**SECOND AMENDED
SITE PLAN FOR SUBDIVISION**

DRB Submittal
JUNE 20, 2002

**Heart Institute
Medical Office Building**

**Tract 2B1
Site Development Plan
for Building Permit**

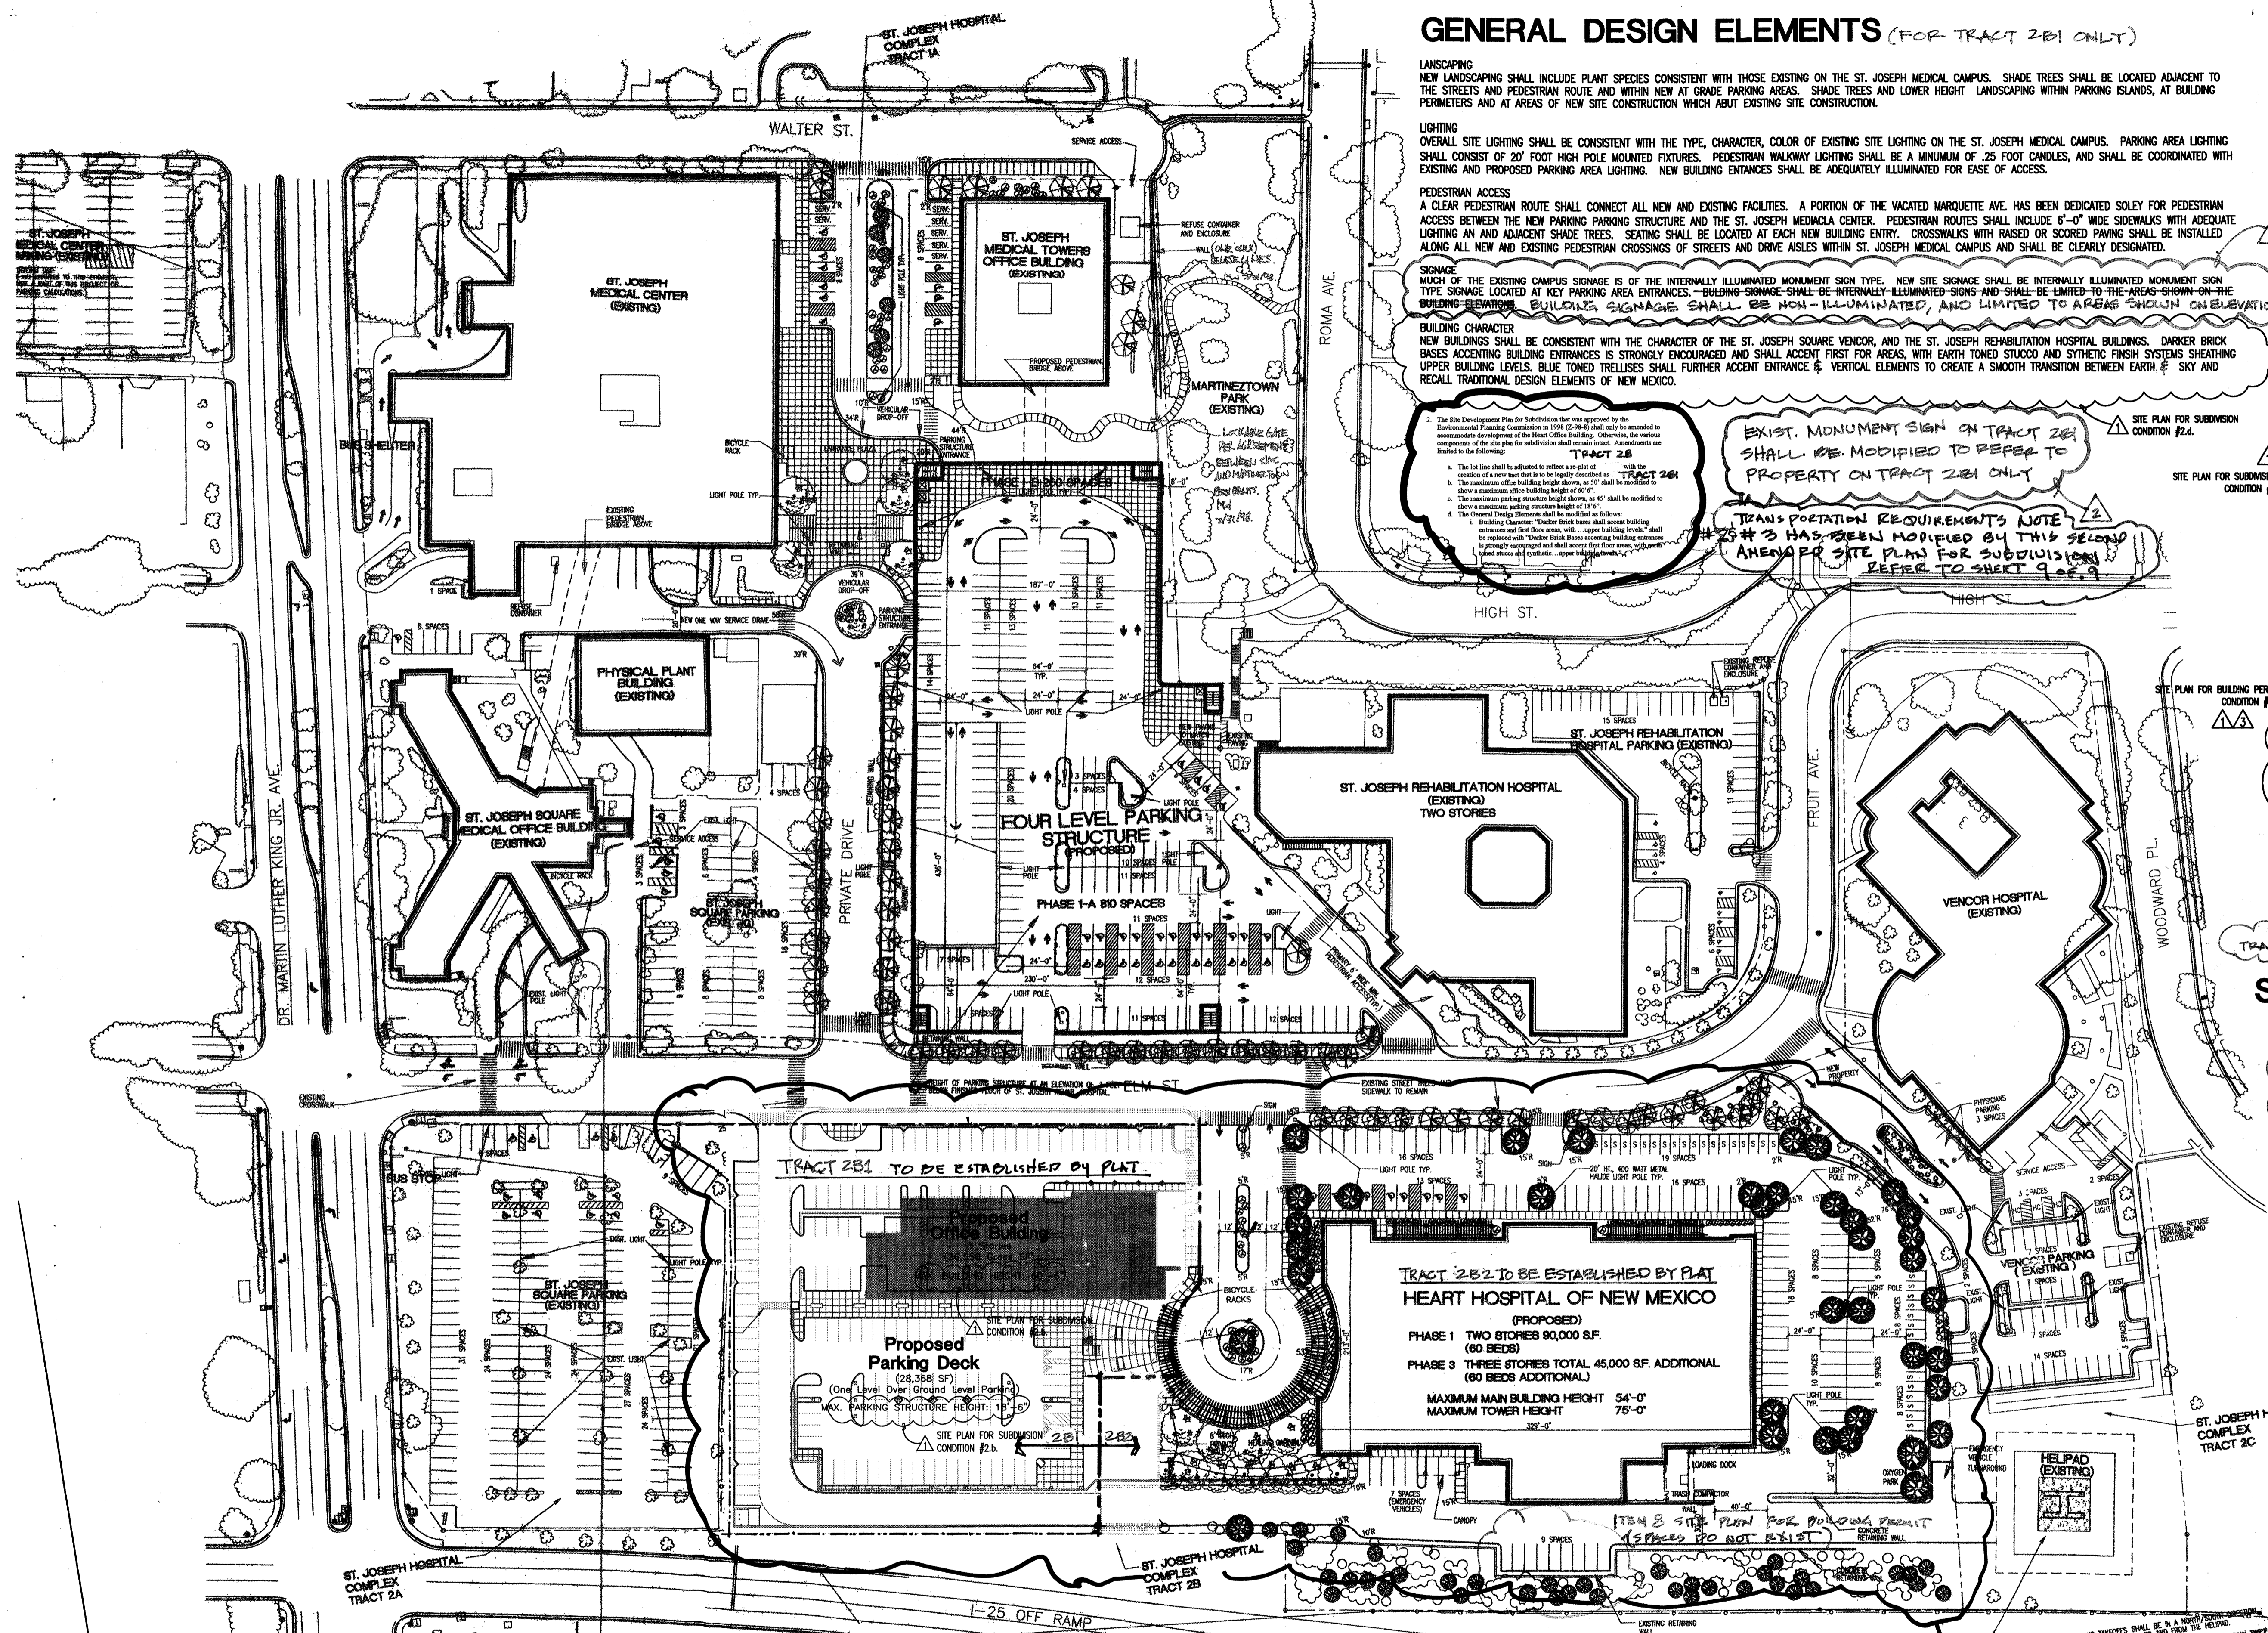
2. The Site Development Plan for Subdivision that was approved by the Environmental Planning Commission in 1992 (EPC 92-01) shall only be amended to accommodate development of the Heart Office Building. Otherwise, the various components of the site plan for subdivisions shall remain intact. Amendments are limited to the following:
TRACT 2B

1. The lot line shall be adjusted to reflect a re-plot of the entire site.
2. The maximum office building height shown, at 50' shall be modified to show a maximum office building height of 60'.

3. The maximum parking structure height shown, at 45' shall be modified to show a maximum parking structure height of 60'.
4. The General Design Elements shall be modified as follows:

a. Building Character: "Darker brick bases shall accent building entrances and first floor areas, with upper building levels" shall be replaced with "Darker brick bases accenting building entrances and first floor areas, with upper building levels" shall be properly reworded and shall appear on the floor plan, with appropriate notes and details, upper building levels.

EXIST. MONUMENT SIGN ON TRACT 2B1 SHALL BE MODIFIED TO REFER TO PROPERTY ON TRACT 2B1 ONLY

TRANSPORTATION REQUIREMENTS NOTE #25 #3 HAS BEEN MODIFIED BY THIS SECOND AMENDED SITE PLAN FOR SUBDIVISION REFER TO SHEET 9.6.9

SITE DEVELOPMENT PLAN FOR SUBDIVISION

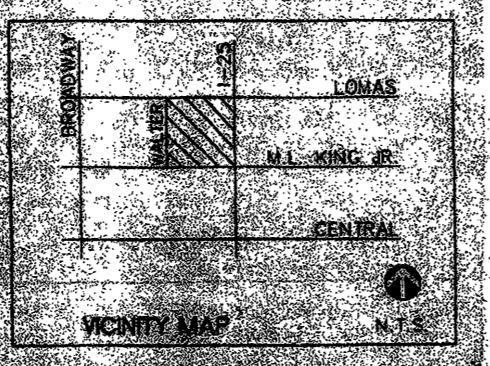
This Note was included on the site plan for subdivision in anticipation of a hotel being constructed on this site.

Any future development that exceeds the O.P.M. TIS threshold will require a traffic impact study.

SEE SHIT. A1 OF THIS SUBMITTAL FOR AMENDMENTS PERTAINING TO TRACT 2B ONLY
